Video Products Technical Bulletin 30-2004-032

SUBJECT: **NO PICTURE FROM DAMAGE TO Q613 ON G BOARD**

MODEL: ***BVM-D14H1A***
BVM-D14H1E
BVM-D14H1U
BVM-D14H5A
BVM-D14H5E
BVM-D14H5U

Figure 1

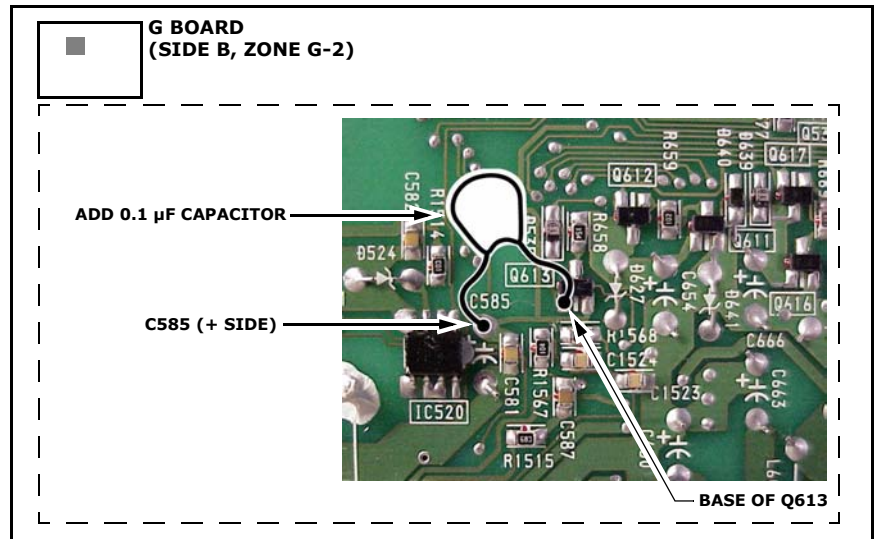
The picture may disappear if Q613 on the G board is damaged and the protection circuit operates.

G Board (Side B, Zone G-2)

1. Solder a 0.1 μ F capacitor between the base of Q613 and the positive (+) side of C585. (See Figure 1.)
2. Affix the capacitor to the board with bond.
